Kawasaki SERVICE INFORMATION

Category Factory Directed Modification	
Model KVF750-A1/B1	
Serial No. DC8971A/2A	Date Dec. 13, 2005

Tie-rod End Ball Separation (RECALL)

REVISED

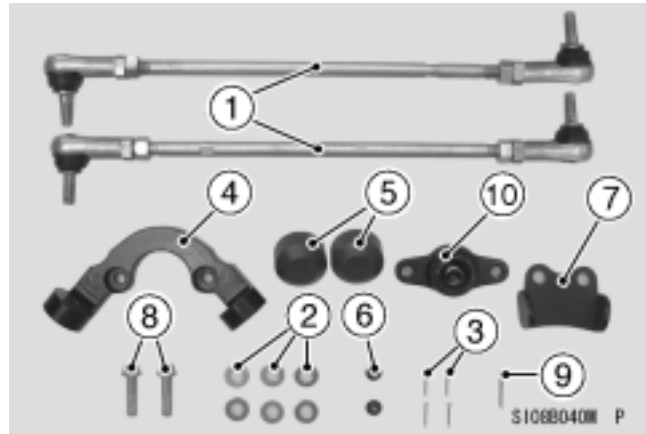
Kit, Rod-Assy-Tie contents: 99999-0084

Kit, Rod-Assy-Tie contents: 99999-0086

- (1) Rod-Assy, Tie
- (2) Washer, 10.2×20×1.5
- (3) Pin-Cotter, 2.0×15
- (4) Holder-Damper
- (5) Damper
- (6) Nut, Lock, 6mm
- (7) Bracket, Steering
- (8) Bolt, 8×35
- (9) Pin-Cotter, 3.0×25
- (10) Joint-Ball

(for Kit, Rod-Assy-Tie P/N 99999-0084)

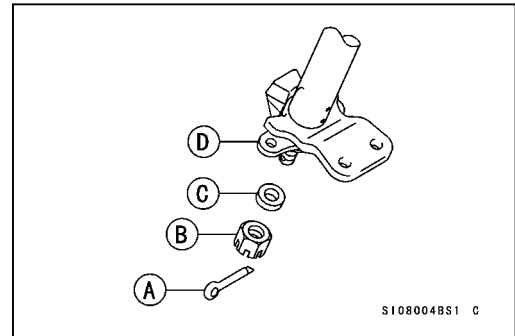
- Remove cotter pins, tie-rod end nuts, washers and tie-rod assy [A].

- Remove steering stem bearing joint bolts [A].
- Lift the steering stem.
- Remove cotter pin [A], steering stem bottom end nut [B] and collar [C].
- Remove steering stem bearing [D].

- Fill grease up the seal grooves in new steering stem bearing.
- Lift the steering stem and install the steering stem bearing.
- Install the collar.
- Tighten steering stem bottom end nut.

- Install new holder (damper) [A] on the steering stem bearing.
- Tighten new steering stem bearing and new holder with new joint bolts [B] (both sides).

< Install Tie-rod Assy >

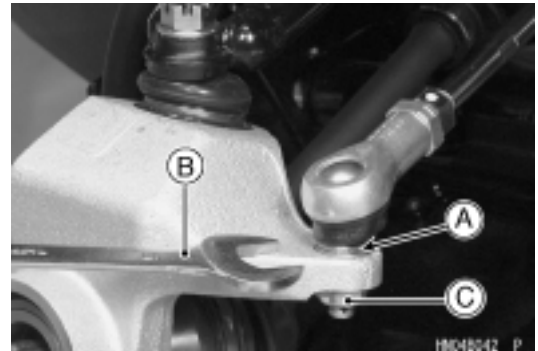
Do not loosen the tie rod end locknuts on the new tie-rod assy before installing tie-rod assy. Tie rod ends and tie rods are pre-assembled at the proper length and angle.

- Install new tie-rod assy and washers (refer to first illustration).
- Hold the flat surface [A] of the tie-rod end with a thin wrench [B], and tighten the tie-rod end nut [C].

Tie-rod End Nuts:

42 N·m (4.3 kgf·m, 31 ft·lb)

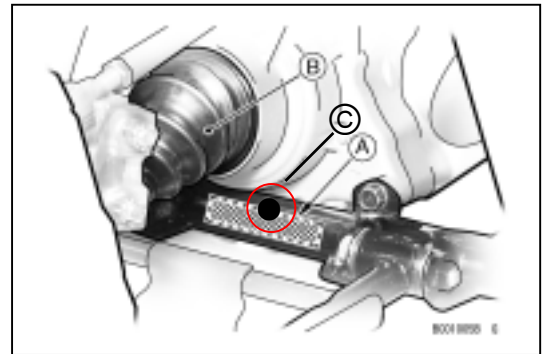
Allowing the tie rod end body to contact the shaft while loosening or tightening the tie rod locknuts can cause damage to the tie rod end and result in failure of steering components. Hold the tie rod end with a wrench when loosening or tightening the tie rod locknuts and make sure the tie rod ends are aligned 180° opposed.

Handlebar misalignment or unequal tie rod adjustment can cause the vehicle to drift left or right, or mishandle which could lead to an accident. Operate the vehicle slowly after handlebar alignment and toe-in adjustment to check that the steering responds correctly and the handlebar is straight when the vehicle is traveling in a straight line. If not, re-check the handlebar alignment and toe-in adjustment.
